## CORNELL RESPONSES TO QUESTIONS AND COMMENTS ON CORNELL ULURP APPLICATIONS

(Questions by LARRY PARNES, 11/18/12)

**SECTION: ZR 133-31(b)**

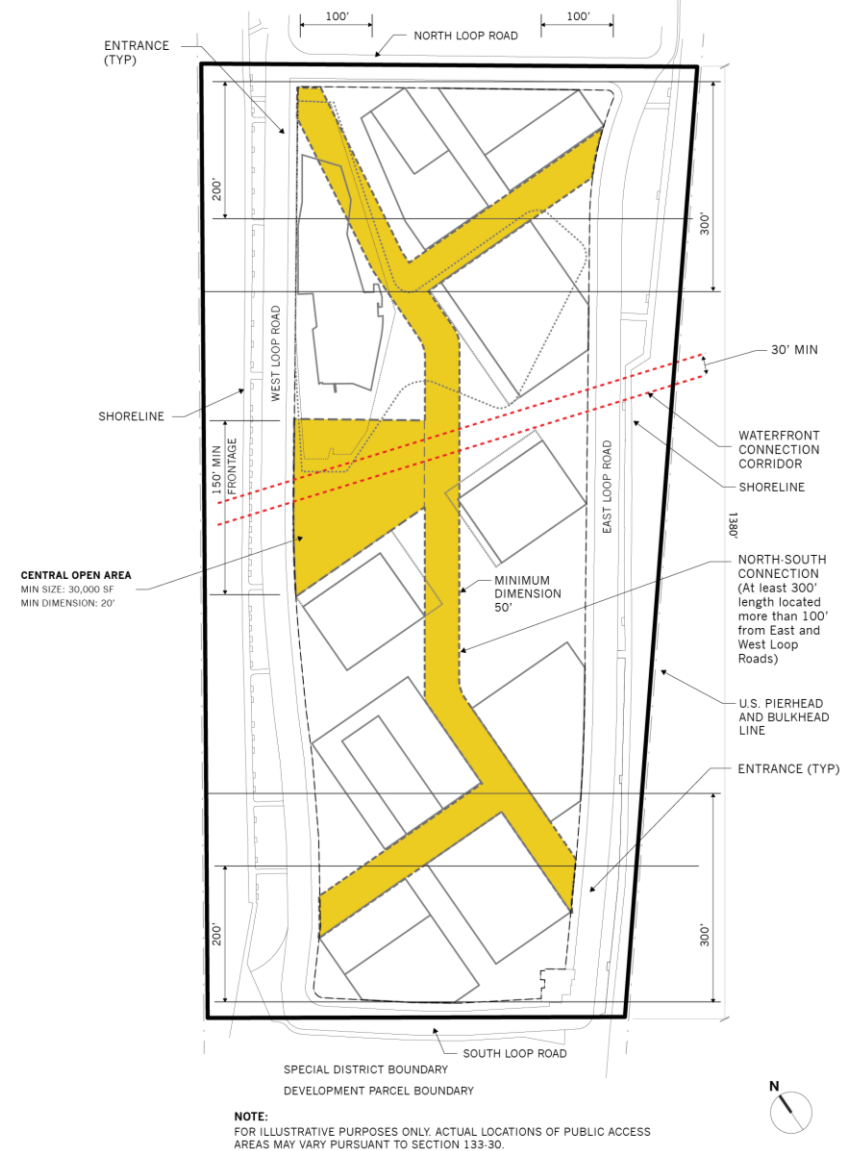
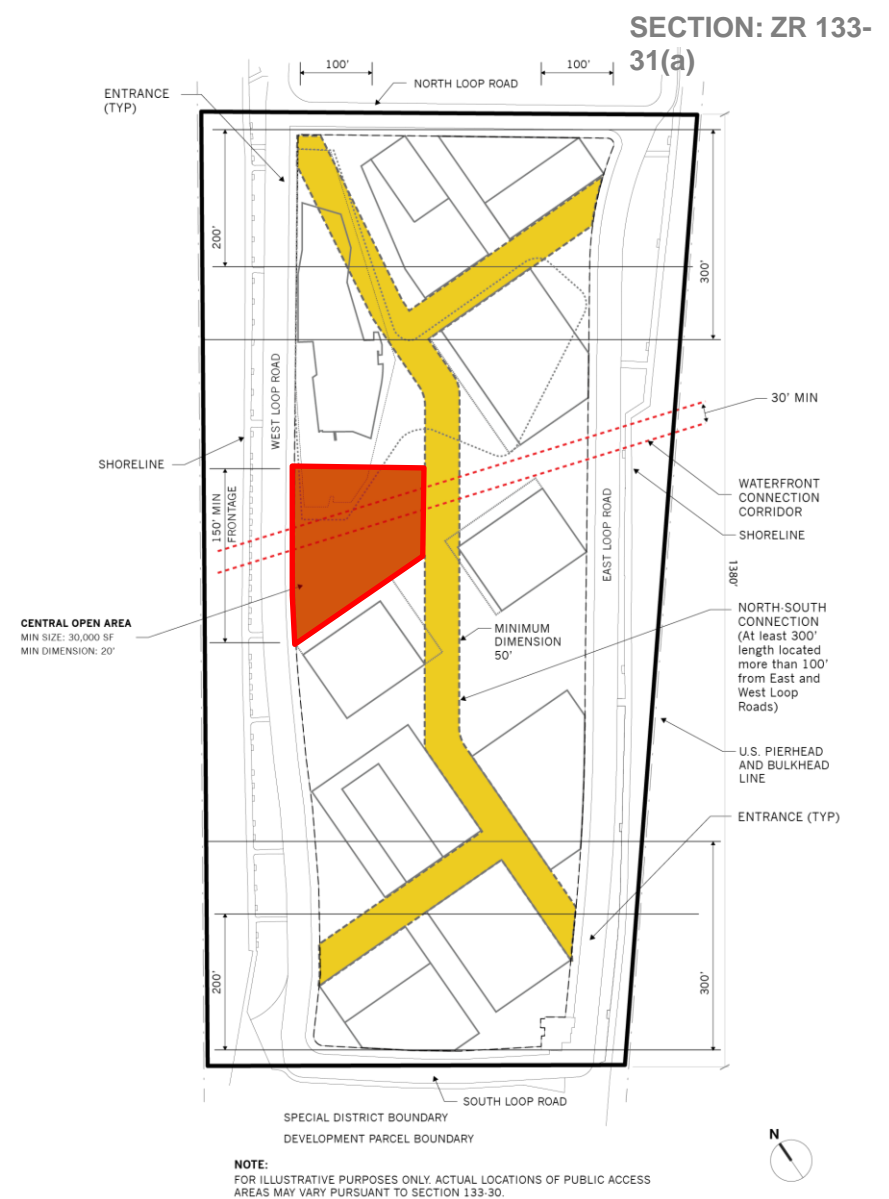
- Section 133-31 (b) - an illustrative drawing would be useful. What is the difference between sections 133-31(b) and 133-31(c)? In 131-31(c), shouldn't the term "street line" be used instead of boundary?

**RESPONSE:** An illustrative drawing showing the open space areas is attached. Paragraph (b) relates to a 50' wide North-South corridor that will run the length of the campus from the proximity of the North Loop Road to the South Loop Road. Paragraph (c) relates to an at least 30' wide connection that runs east-west. The only reason for the use of "boundary" rather than "street line" in the text is to account for the fact that there will be a short period between adoption of the zoning text and the formal mapping of the streets.
